# SERVICE INSTRUCTION

SI-34-02  
Revision 1

**TITLE: Flap Indicator Replacement**

### **Found Aircraft Canada Inc.**

**Figure 2 Updated System Installation Schematic**

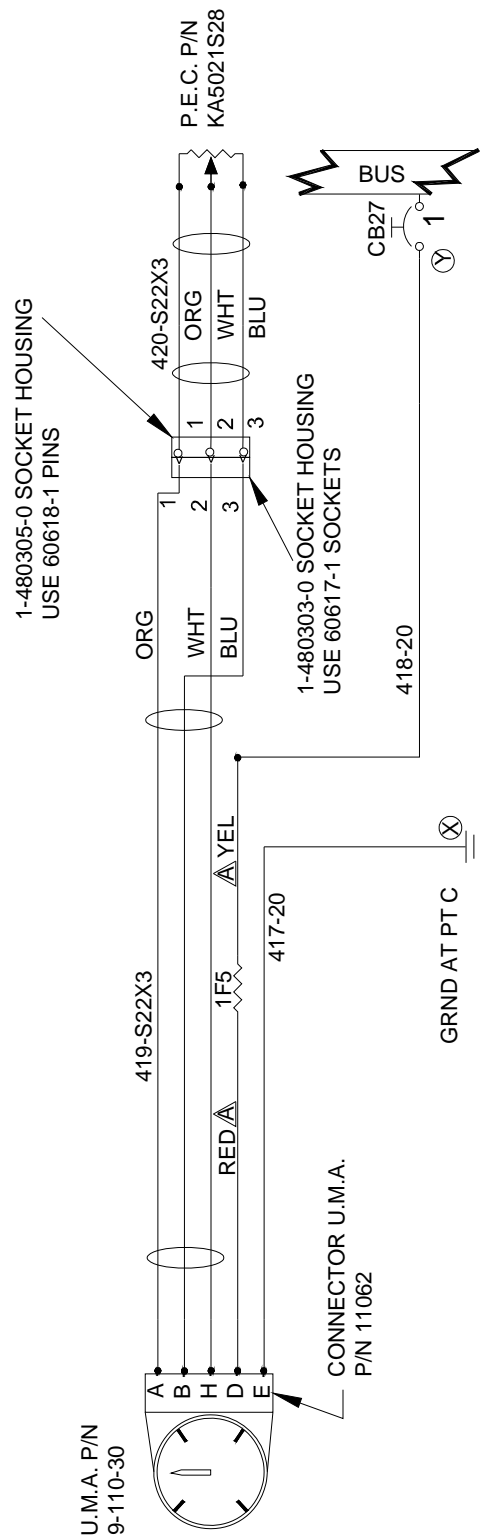
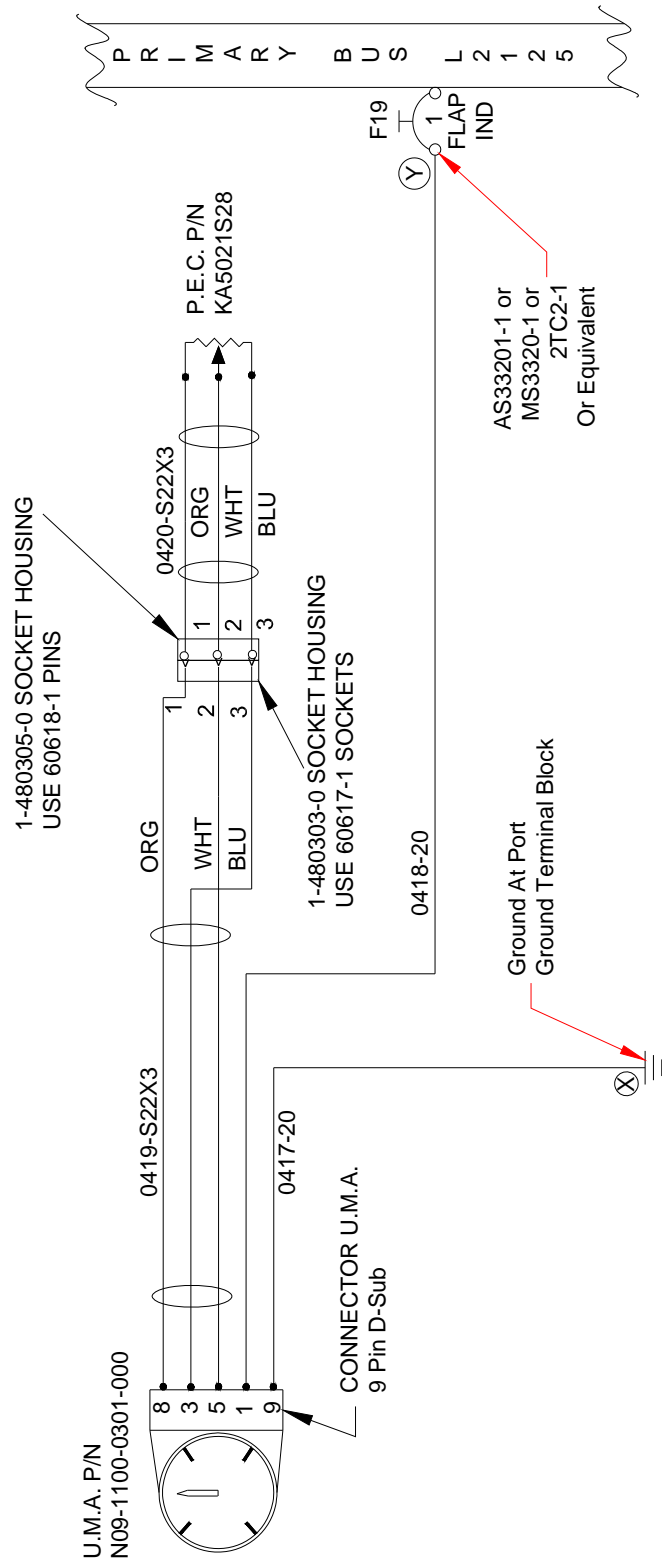
At Revision 1 Figure 2 has been corrected to show the proper pin designations for the flap gauge, UMA Instruments p/n N0911000301000.

1. Figure 1 shows the original flap indicator system schematic. Figure 2 shows the updated flap indicator schematic. The installation technician will note the similarity between the two installations but for two items: The updated schematic no longer has the 1F5 resistor and the 9- Pin D-Sub connector uses numerals rather than letters to designate positions.
2. The technician shall disconnect the wires as shown in Figure 3 and attach the new connector per Figure 4. Extend or shorten wires as required.
3. Any replacement wires shall be M22759/16, M27500 or equivalent.
4. All wiring shall be installed per AC43.13-1A - latest revision.

Figure 4 UMA 9-Pin D-Sub

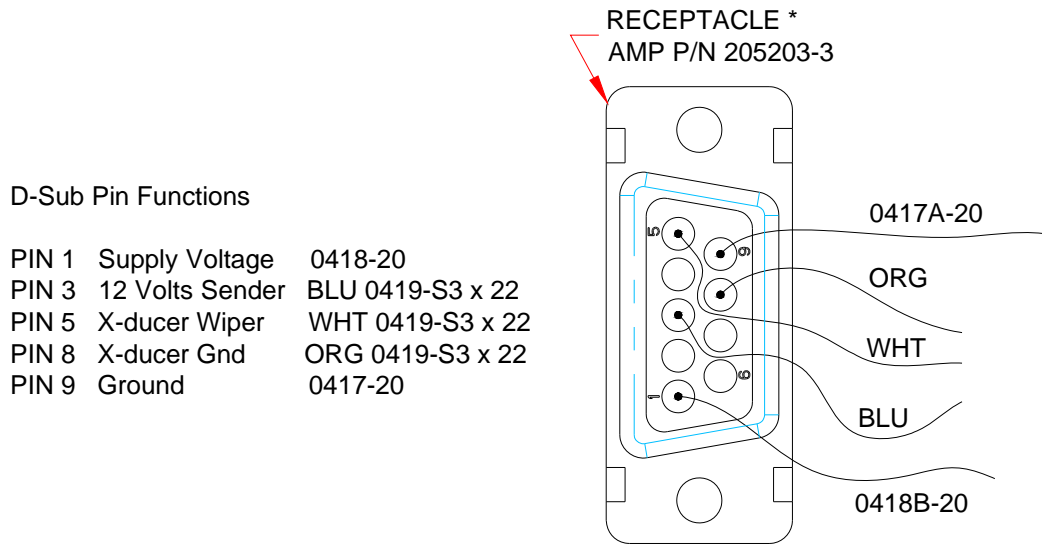
PIN 1	Supply Voltage	0418-20
PIN 3	12 Volts Sender	BLU 0419-S3 x 22
PIN 5	X-ducer Wiper	WHT 0419-S3 x 22
PIN 8	X-ducer Gnd	ORG 0419-S3 x 22
PIN 9	Ground	0417-20
